Addendum No. 1

PROJECT: WOODROW WILSON HOUSE BUILDING SYSTEMS UPGRADES

RE: ADDENDUM NO. 1 TO REQUEST FOR PROPOSALS, ISSUED MARCH 2, 2022

PasteFrame.com 3

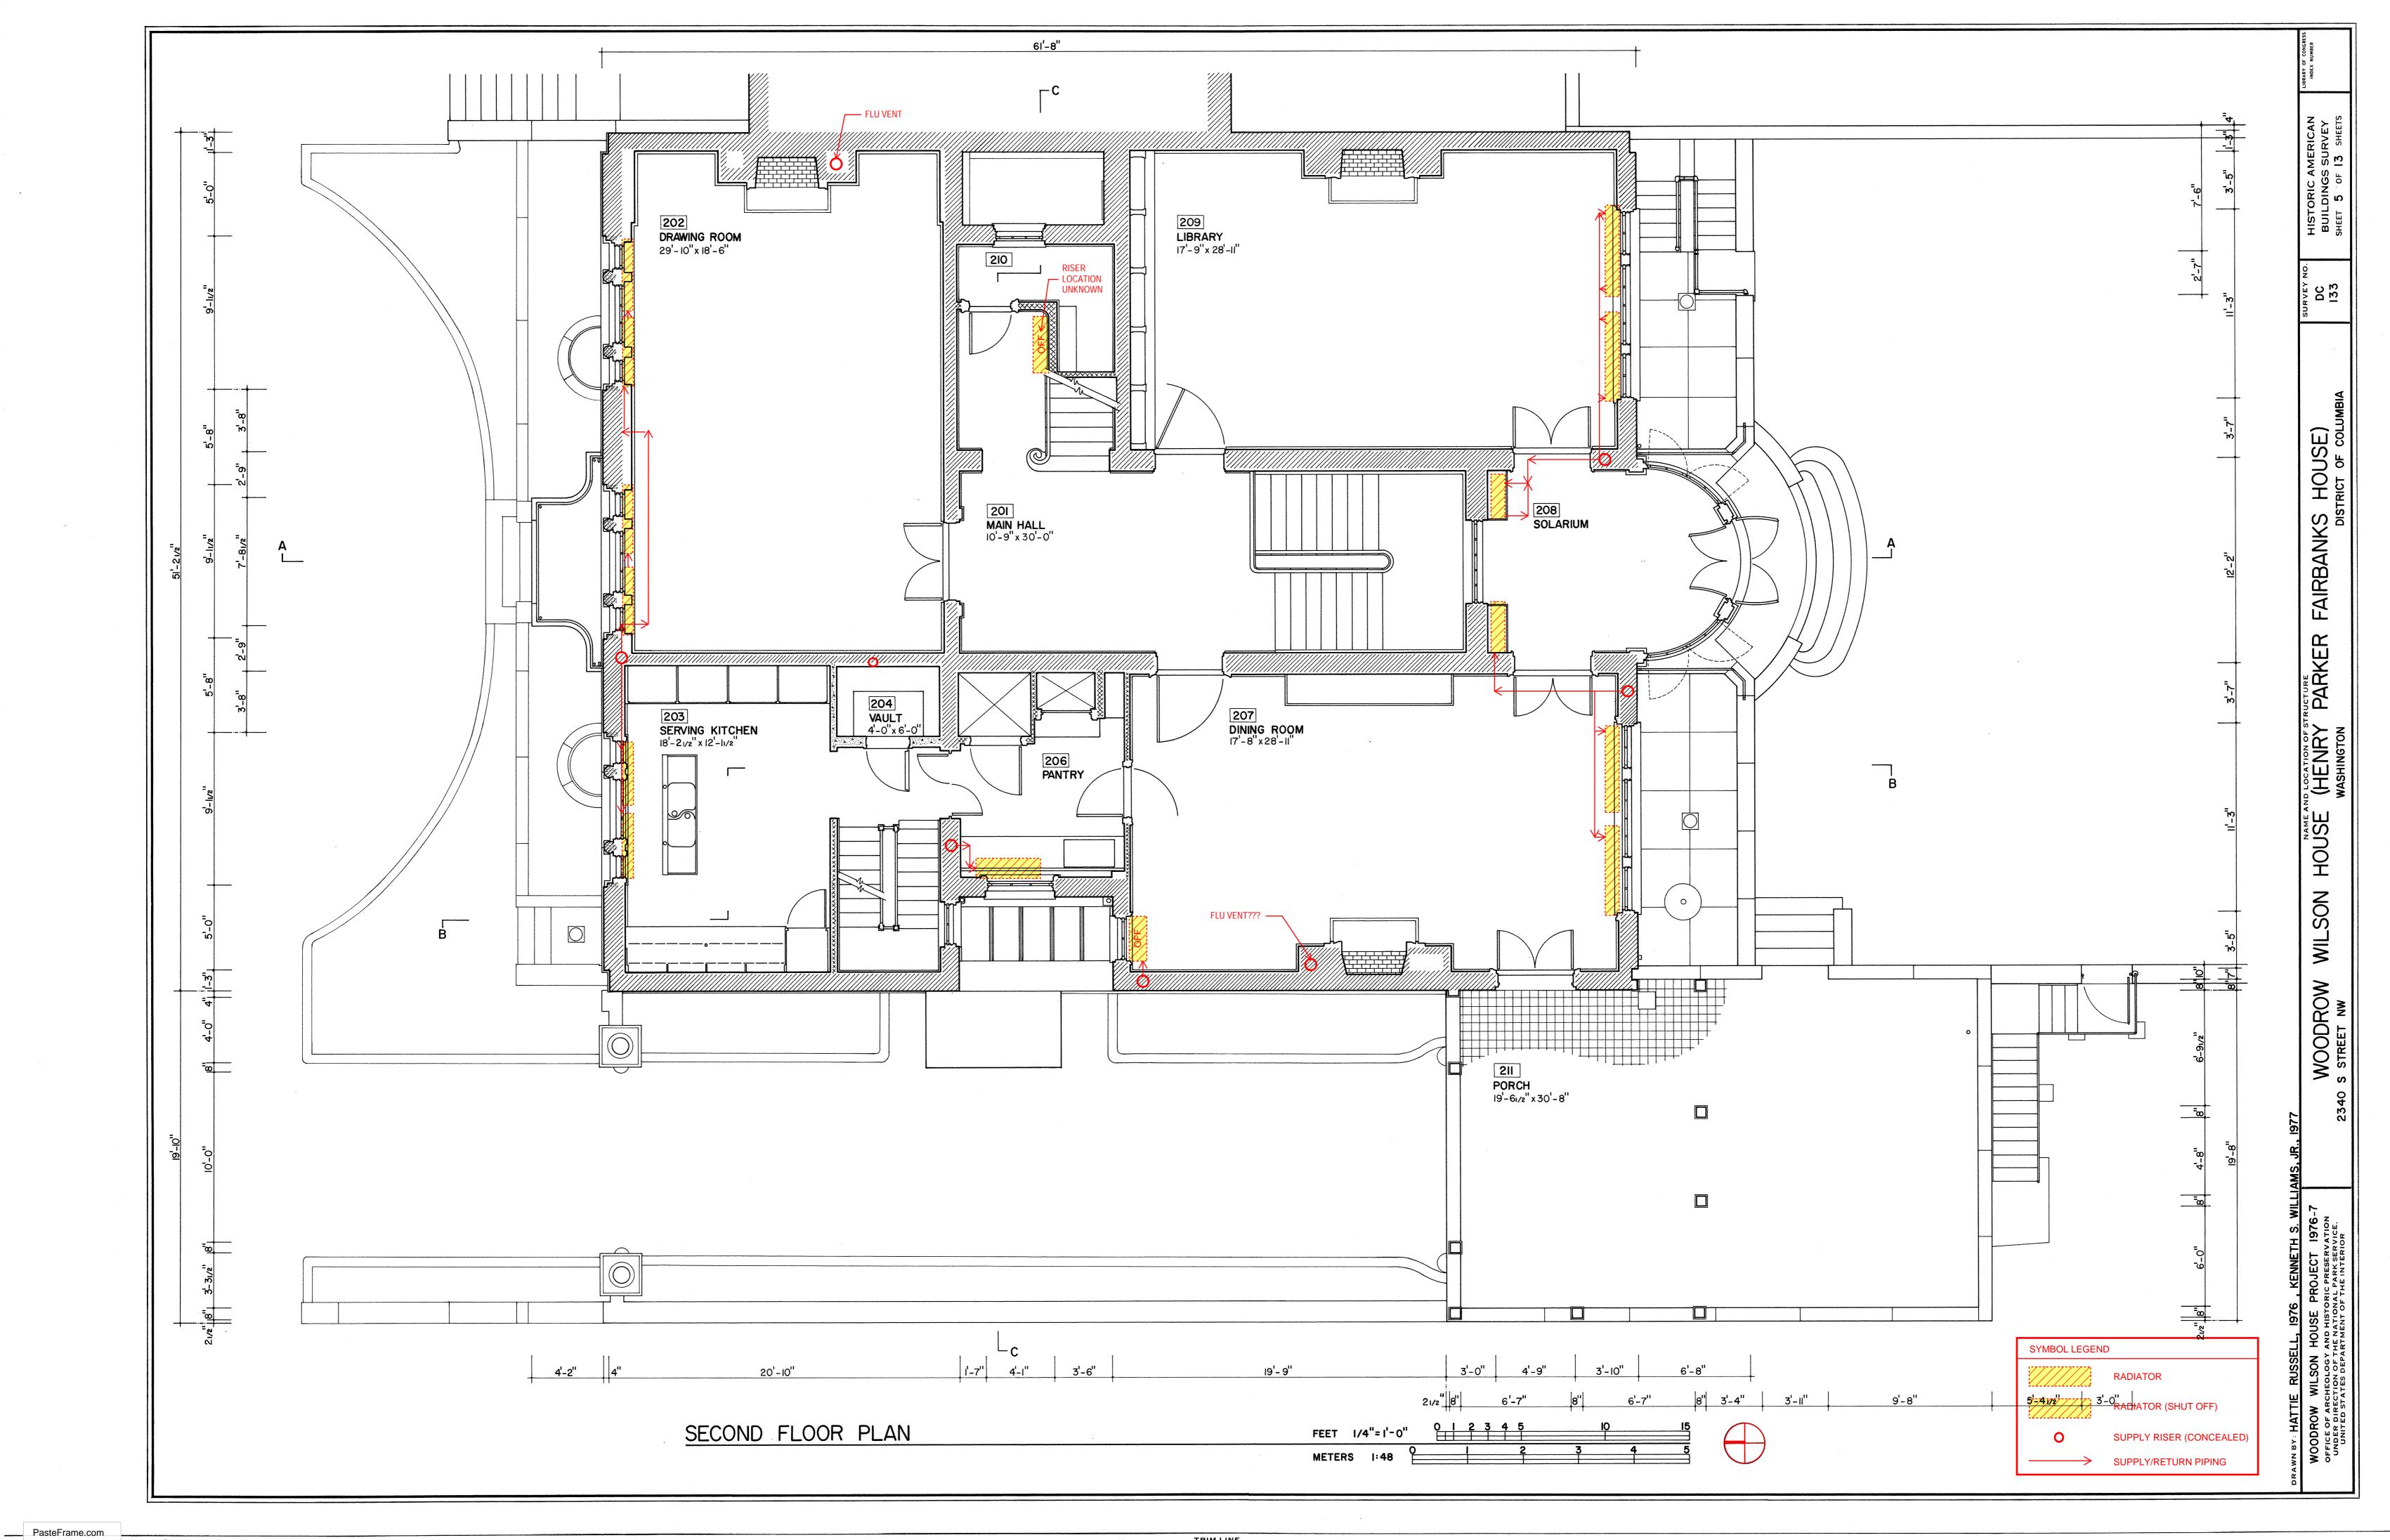
- Q: Would the National Trust provide the marked-up plan of the existing steam piping routing that was discussed during the walkthrough?
- A: The steam piping routing plan is attached to this Addendum. Note, these riser diagrams were determined by thermal imaging and may be incomplete.

- A: The steam piping routing plan is attached to this Addendum. Note, these riser diagrams were determined by thermal imaging and may be incomplete.
- Q: Please confirm that budget pricing to be provided is for the MEP costs only. Cost for Architectural work is by others.
